**3750 WD JUDGE DRIVE- FERN GROVE PHASE II
PD AMENDMENT**

SUMMARY

<p>Owner BDG Leasing LLC</p> <p>Applicant Aimee Sheilds (GAI)</p> <p>Project Planner Michele Gibbs</p> <p>Updated: April 14, 2026</p>	<p>Property Location: 3750 WD Judge Dr. The subject property is generally located north of W. Colonial Drive, east of Mercy Drive, south of WD Judge Drive, and west of Ferguson Drive; (±9.9 acres); District 5.</p> <p>Applicant's Request: The applicant requests a Planned Development amendment for the previously approved 258-unit senior affordable housing project by reducing the total number of approved parking spaces from 335 to 260 for the overall phase.</p>	<p>Staff's Recommendation: Approval of the request, subject to the conditions in this report.</p> <p>Public Comment Courtesy notices were mailed to property owners within 400 ft. of the subject property on the week of April 6, 2026 . As of the published date of this report, staff has not received comments from the public concerning this request.</p>

EXISTING SURVEY

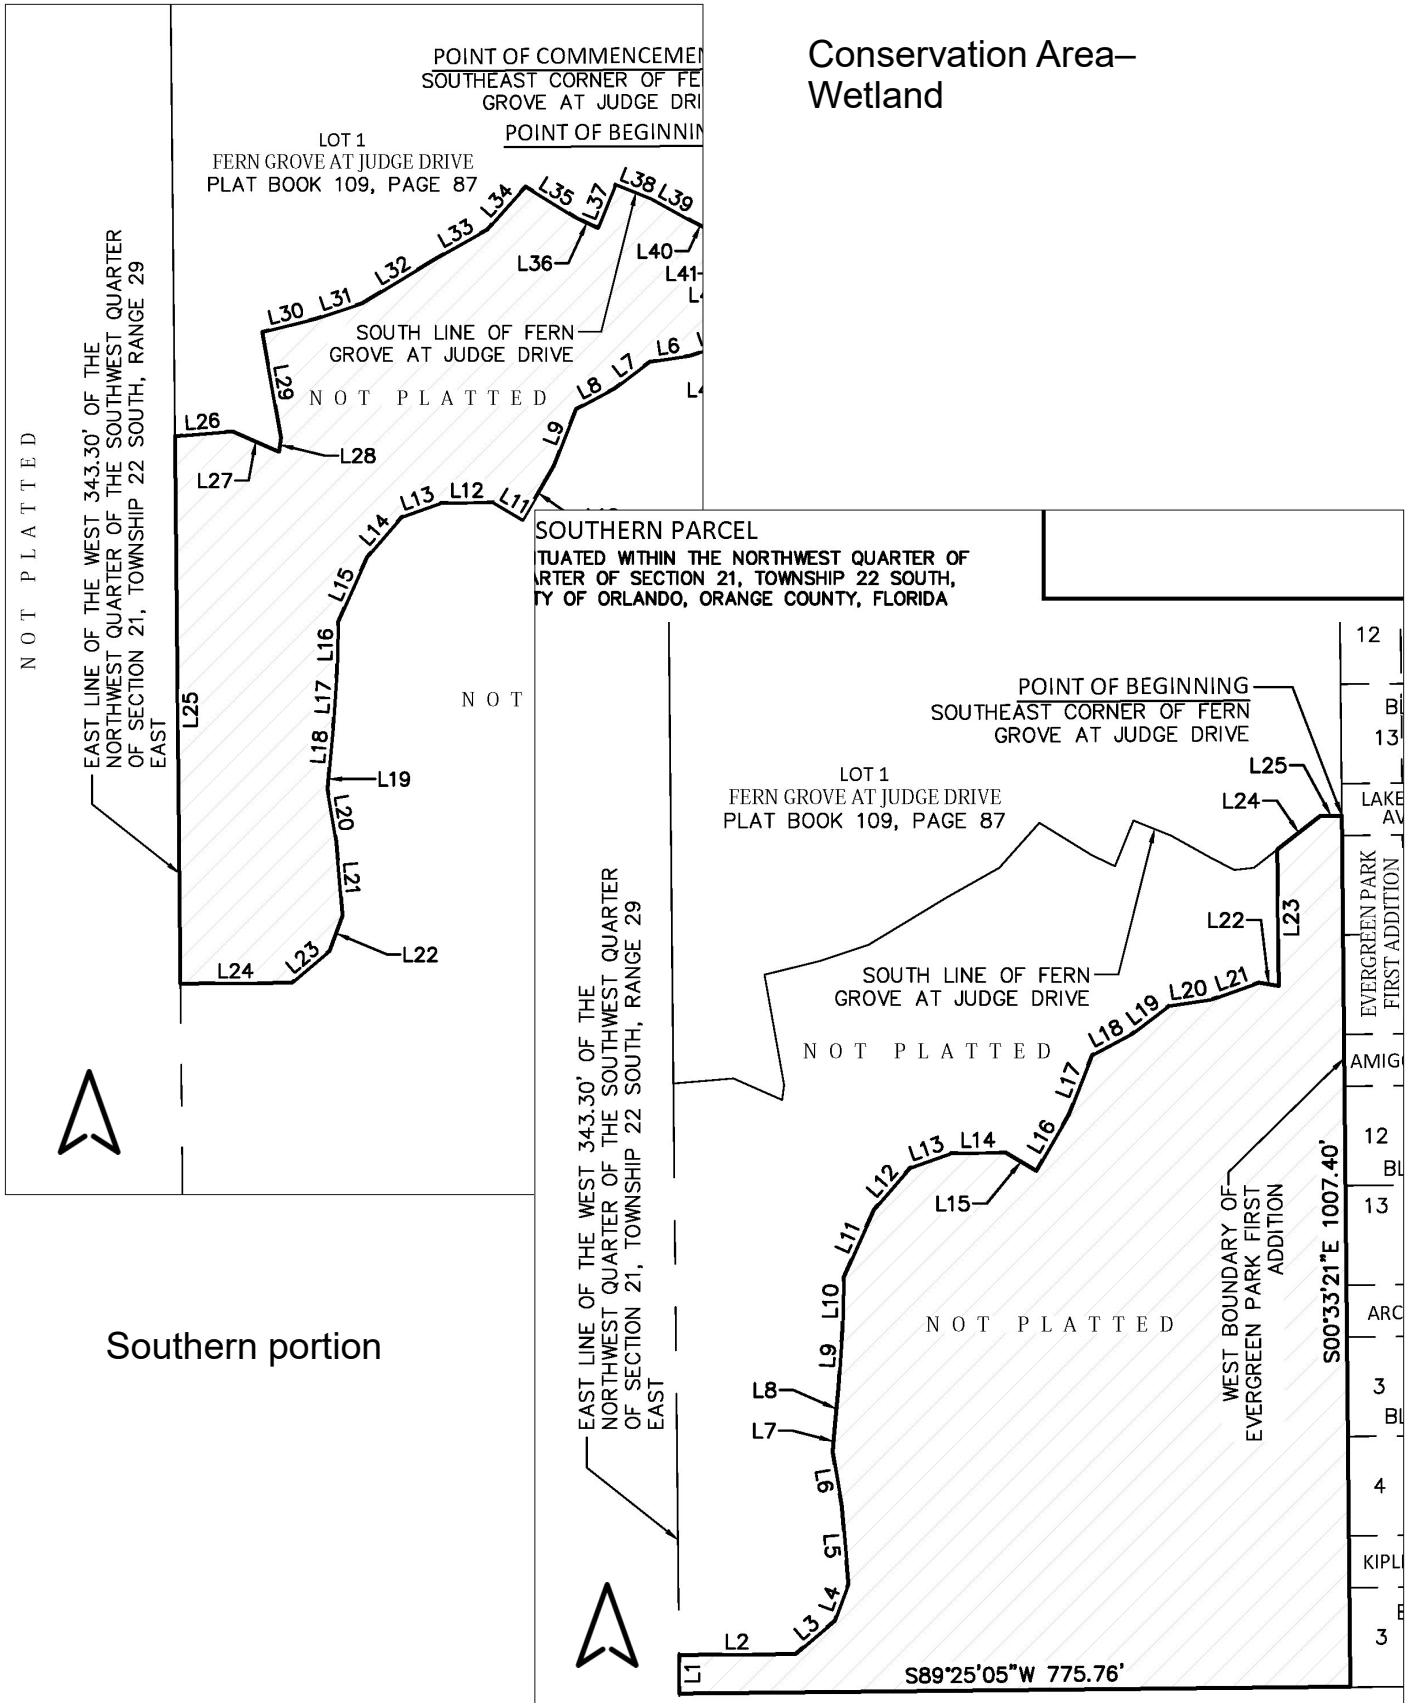
Survey does not specify the horizontal datum of the survey as required. This needs to be resolved prior to construction.

NEW SITE PLAN

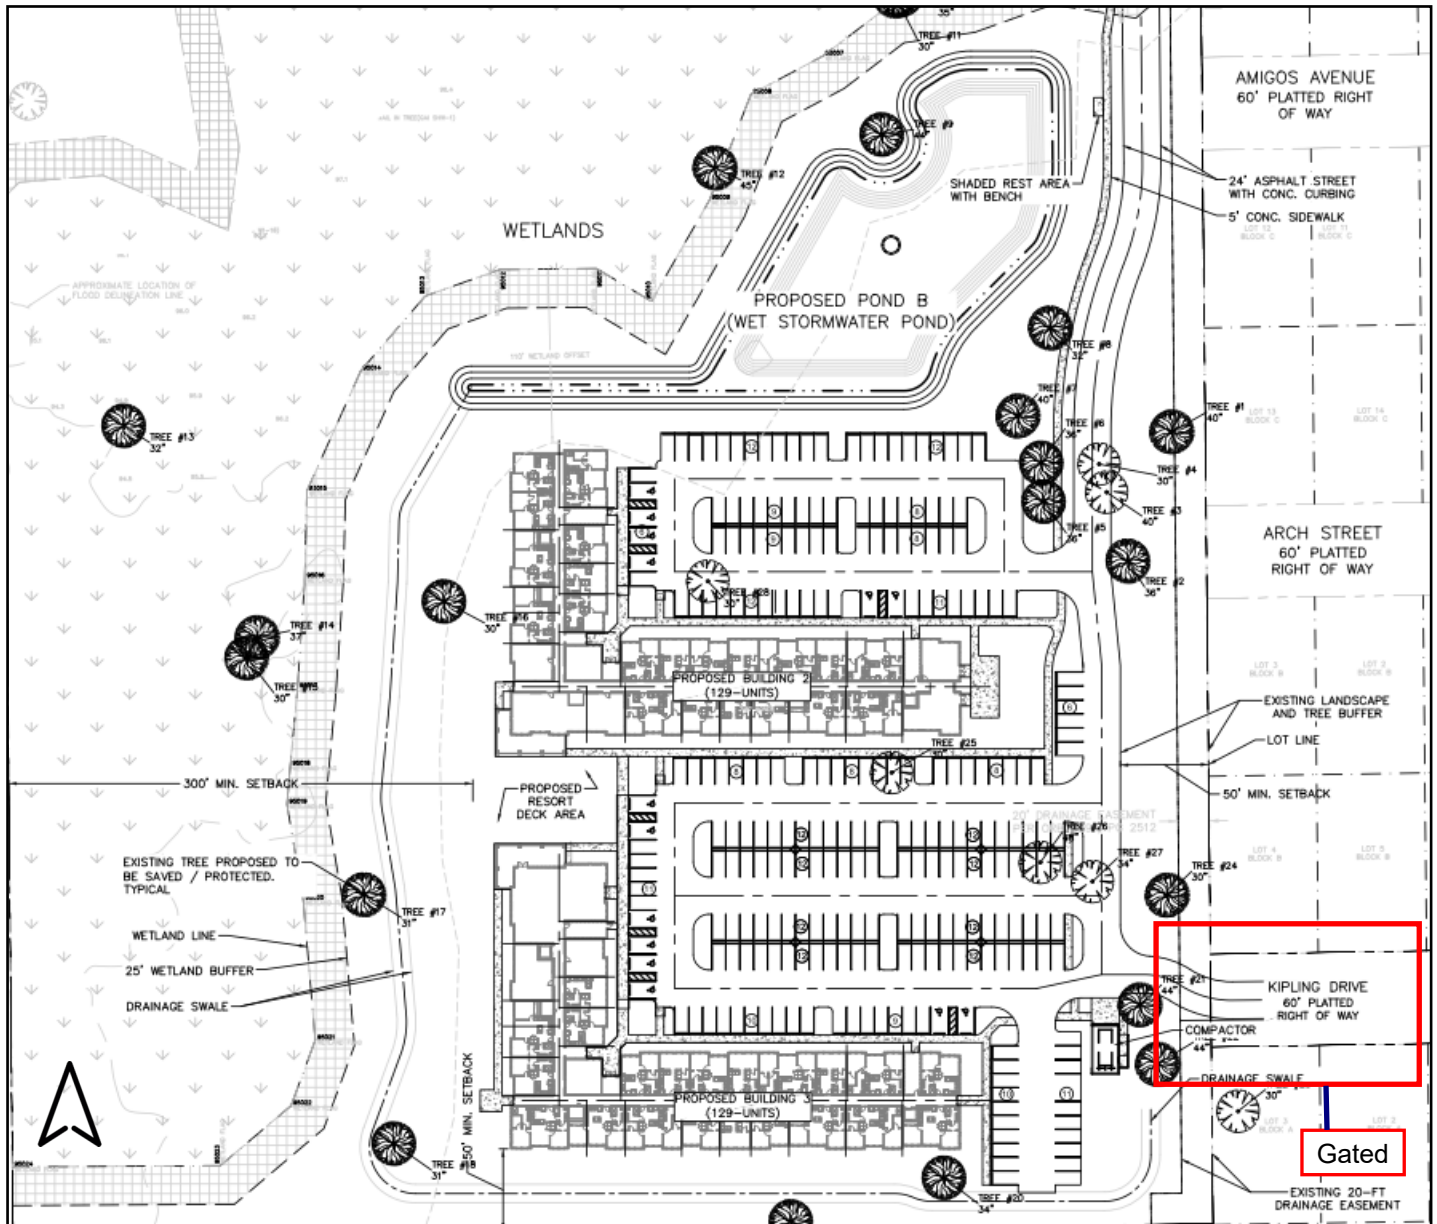
12. At the time of permitting, the applicant must provide improved connectivity for residents from the building proposed in Phase Two to the shared parking spaces south of the building. As presented, someone parking south of the building would need to go around the entire Phase Two building to access the entrance.

18. Condition 5.1 applies to the walkway connections along the east side of the parking lot. Appropriate curb ramps and crosswalk markings are required. These updates must be reflected at the time of permitting.

ELEVATIONS

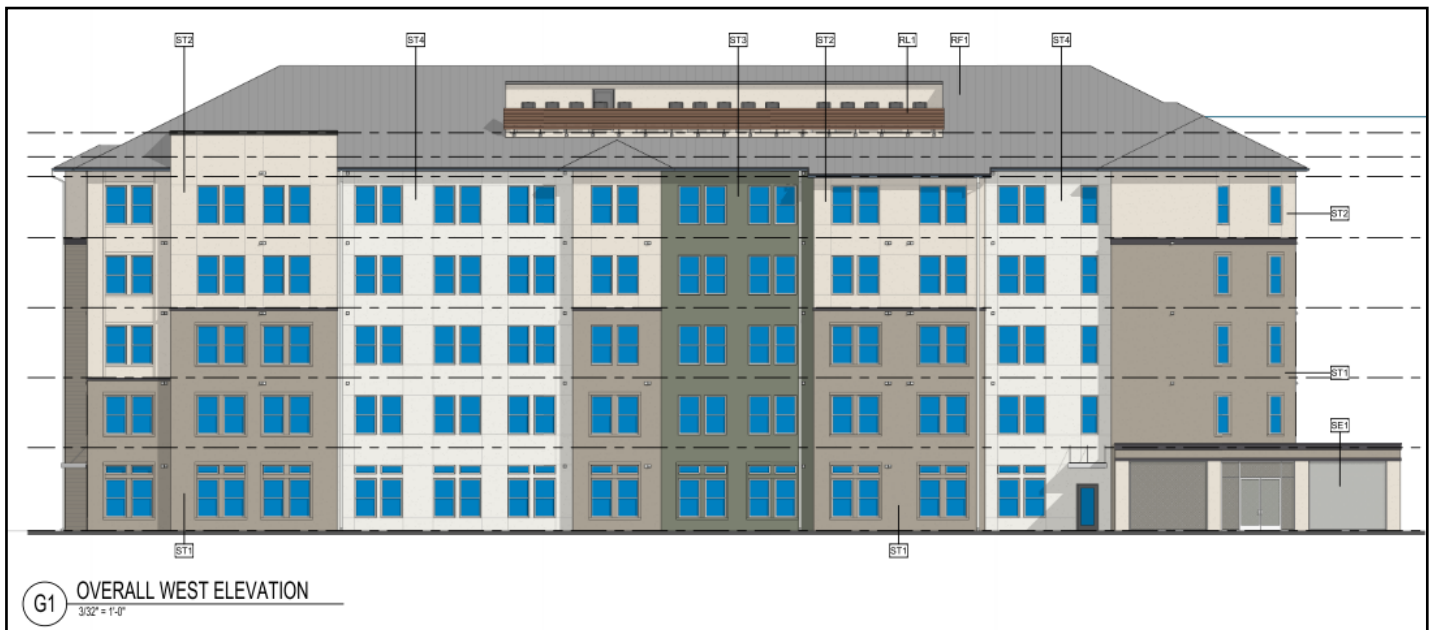
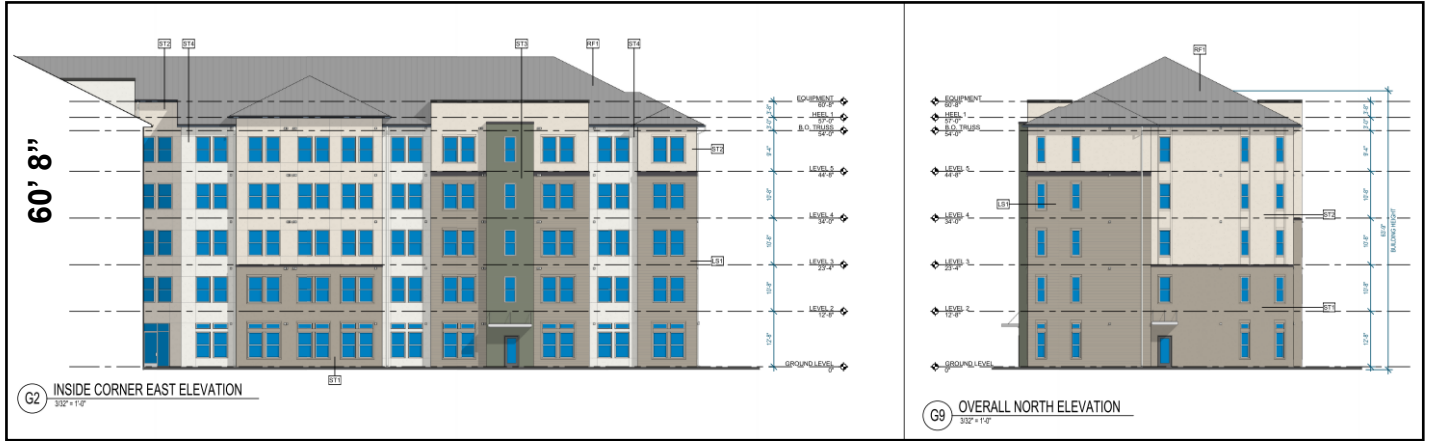
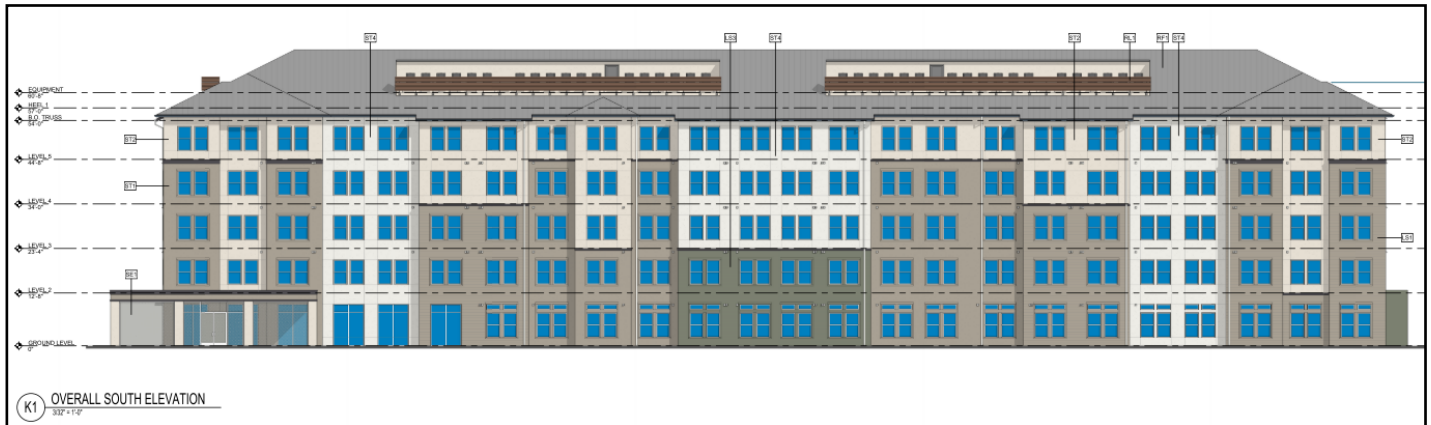
1. Recommendation: Reorient the building so that the current south elevation faces north towards the storm-water pond/wetlands and relocate the parking lot behind the building. This reorientation will encourage closer connectivity from the building to an amenitized stormwater pond and provide more residents with premium views, instead of looking over a field of parking.

2. Architectural features and details must be carried through on all sides of the building.
3. The proposed elevations of both Building 2 and 3 shall meet the following conditions at the time of permitting:

- a. All main entrances shall have an architectural emphasis such as a canopy or pergola that is appropriate to the style of the building
 - b. South elevation: Staff recommends that the hip roof on both ends of the south elevation should be changed to a gable roof style. Continue the facade material on the gable roof. The proposed mechanical equipment screening should match the color of the roof so that it blends with the roof.

- c. West elevation. The proposed mechanical equipment screening should match the color of the roof so that it blends into the roof. Inside corner north elevation.

- d. Recommendation: The hip roofs should be changed to a gable ends. Continue the facade material on the gable roof. Base color of the ground floor should be changed to the darkest beige to create a base to the building.

- e. Inside corner east elevation: Base color of the ground floor should be changed to the darkest beige to create a base to the building. All projecting parapet walls must wrap minimum depth of 5-ft or more, so the parapet walls appear three dimensional. Flat boxy walls are discouraged.
